**GE Hitachi Nuclear Energy**

Subject: GEH Response to Request for Information for Continued use of the Model No. 2000 Package, Certificate of Compliance No. 9228, Docket 71-9228, TAC LA0129

**Attachment 1**  
**Request for Information**  
**For the Model No. 2000 package**  
**Docket No. 71-9228**  
**Use of Inner Shield Liner**

Figure 3b-1. GE 2000 Cask Solid Model.

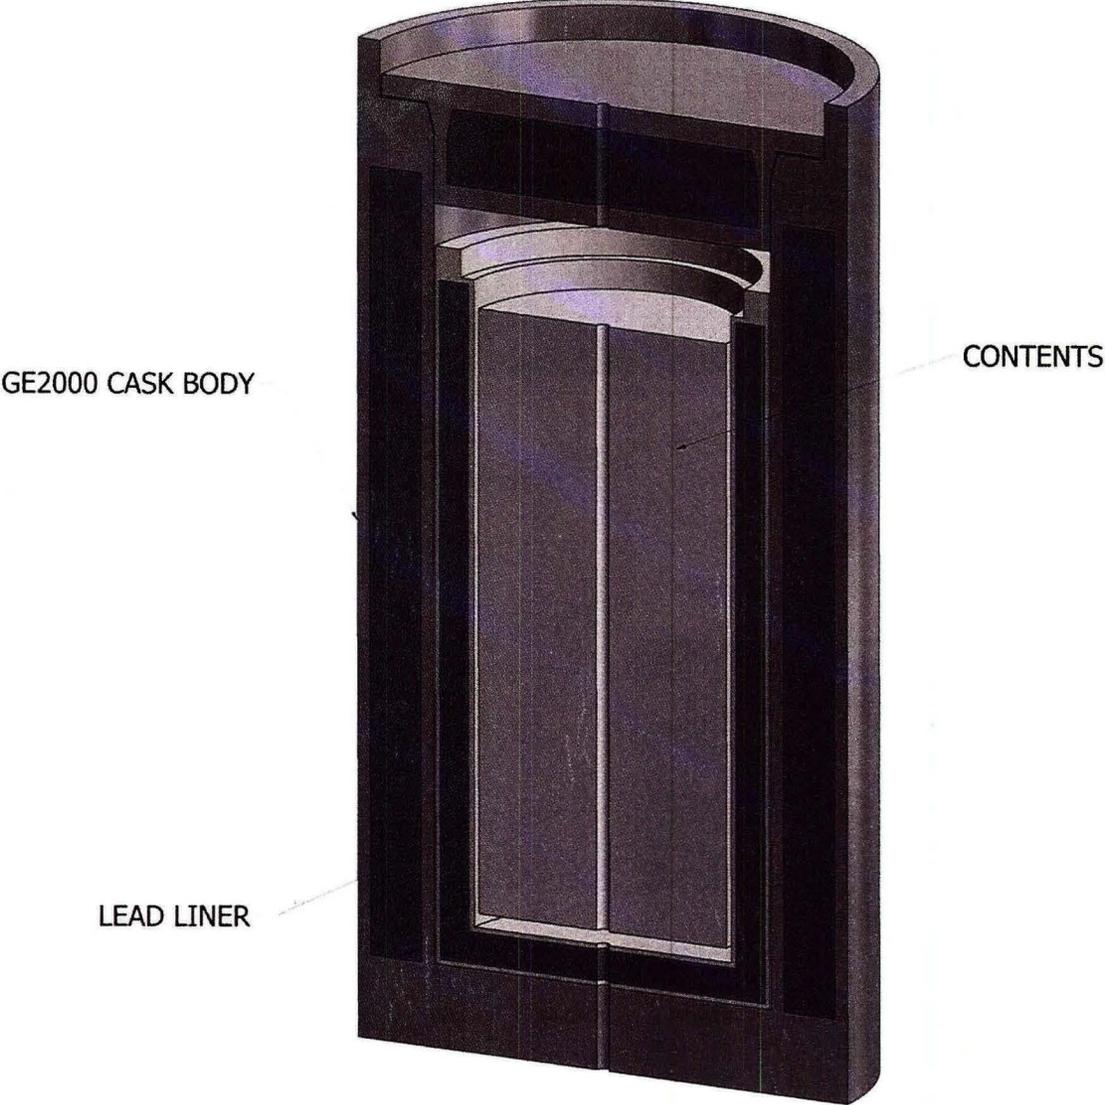
**b. Justify that the shield liner installed in a configuration with and without the shield lid will maintain its configuration under HAC, as credited in application. The package licensing basis used finite element analyses (FEA) and a ¼ scale drop testing for the 30 ft drop test. However, the optional liner does not appear to have been considered in the FEA or scaled drop testing. It also appears that the shield liner could be subject to buckling and failure in a configuration without the shield lid. The liner consists of lead held together with a 0.38" stainless steel shell.**

In the context of the SAR (NEDO-31581) and related certification drawings, an ANSYS finite element model (Reference NRC SFPO ISG-21) was generated to evaluate the stresses of the optional liner. The model includes the GE2000 cask body with lead shield and lid, optional liner without lid, and dummy contents that represents the shoring materials and source payload. The mass of the optional liner and dummy contents is equivalent to the maximum payload weight of 5,450 lb (NEDO-31581, Table 2.10.1.1).

The solid model of the GE 2000 cask was generated from the provided drawings and design input. The 3D (half-symmetry) solid model was generated using Autodesk Inventor, which was imported into ANSYS Workbench Design Modeler. The solid model is shown in Figure 3b-1. The finite element mesh was generated using the ANSYS Workbench Mechanical interface. The finite element model is presented in Figure 3b-2. Boundary conditions are shown in Figure 3b-3.

**Figure 4b-1. GE 2000 Cask NCT Drop Analysis Stress Intensity (psi) Results.  
ORIGINAL CERTIFICATION BASIS**

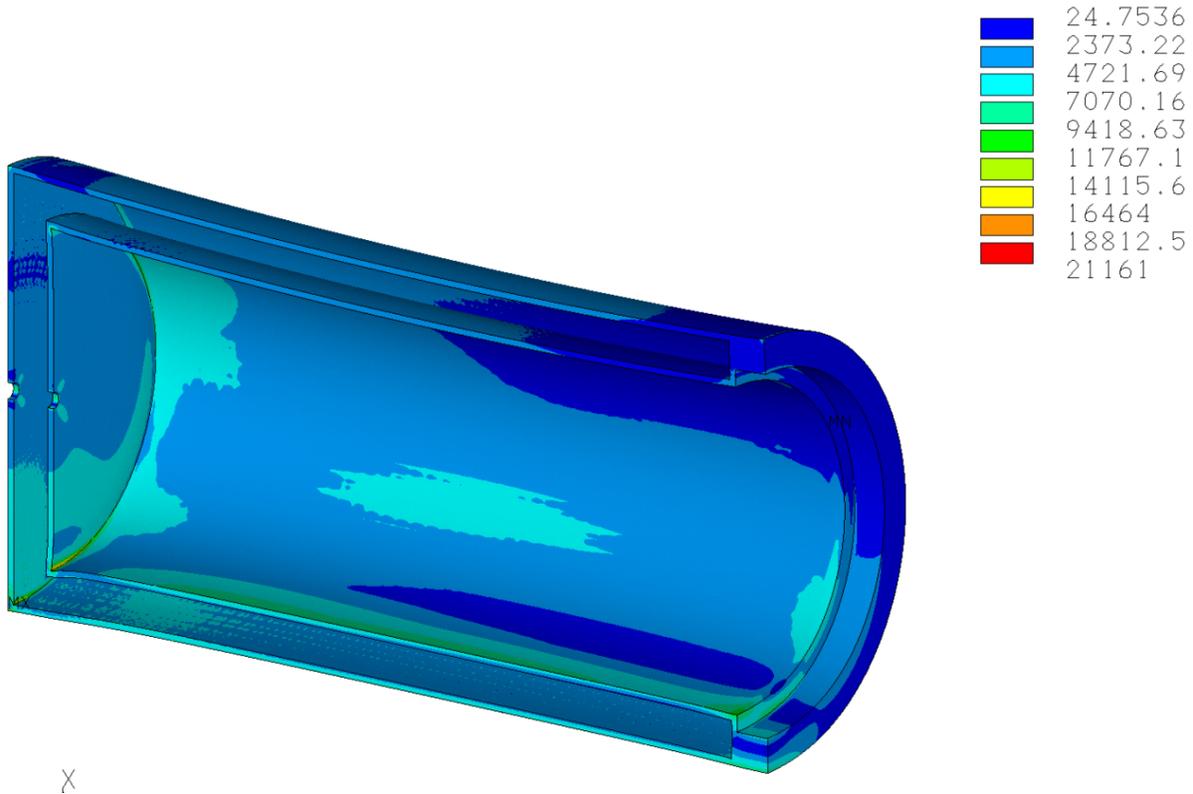
**b. Provide the structural analysis of the optional lead liner for NCT conditions.  
This information is required by the staff to determine compliance with the requirements of 10 CFR 71.47 and 10 CFR 71.71.**

In the context of the SAR (NEDO-31581, Section 2.6.7, p 2-69) and ANSYS finite element model presented in the response to RAI 3b, an acceleration of 69g is applied simultaneously in the +X and +Z directions. This inertial load bounds all NCT drop conditions. Results of the analysis are presented in Figure 4b-1. As the figure shows the peak stress intensity in the liner is less than the yield strength of 304 stainless steel (30,000 psi). Therefore, the structural integrity of the optional liner during NCT drop conditions is acceptable.
